ADDENDUM #3

Coastal Carolina Community College
Administrative Building & Student Center Supplemental Cooling
Jacksonville, North Carolina

ADDENDUM #3
ATTACHMENT #1

Sheet Title
**ADMINISTRATION
BUILDING ROOF
PLAN AND DETAILS**

5 MECH. CURB DETAIL
A101 Scale: 1 1/2" = 1'-0"

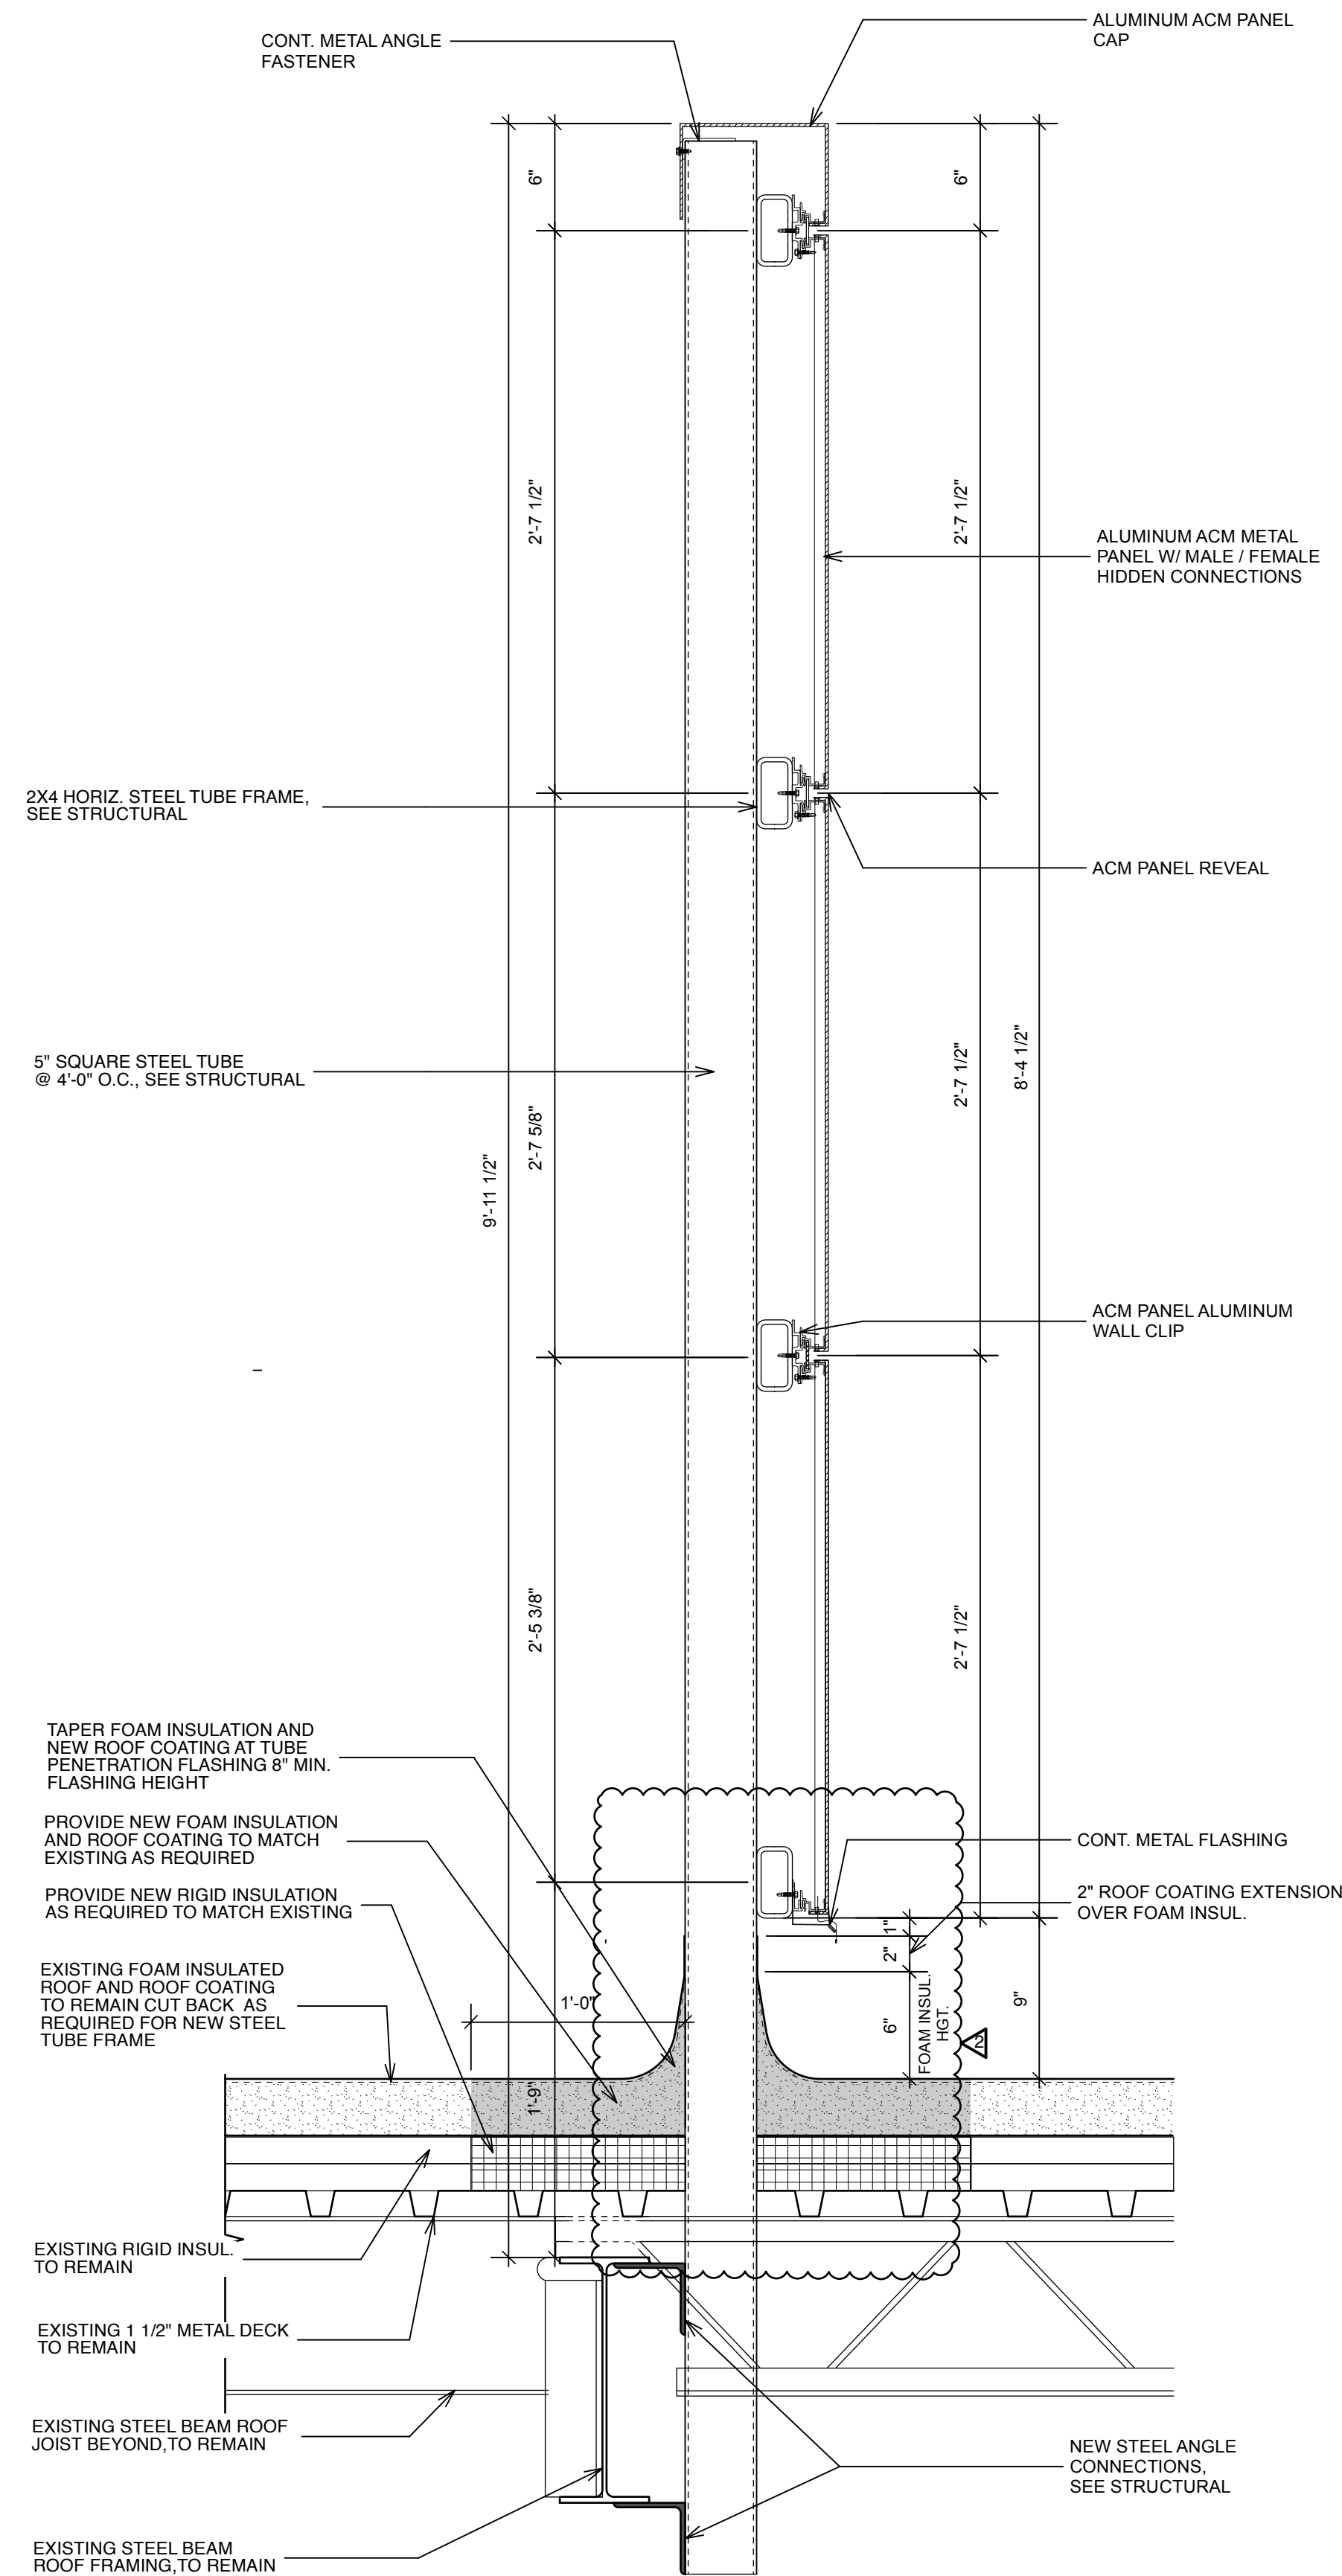
- Item 1** **The bid date, time, and place remain the same:** The bid will be held Thursday, April 24, 2025, at 2:00 pm in the Conference Room of the Institutional Support Services Building at Coastal Carolina Community College, 444 Western Boulevard, Jacksonville, North Carolina 28546.
- Item 2** **Drawing Clarification: Sheet A101.**
Delete the pre-manufactured boot from the penetration details; it is not required per the roof manufacturer's recommendation. **(Attachment #1)**

2	4/16/25	Removed Pipe Boot Flashing
1	2/24/25	COJ COMMENTS
REV.	DATE	DESCRIPTION
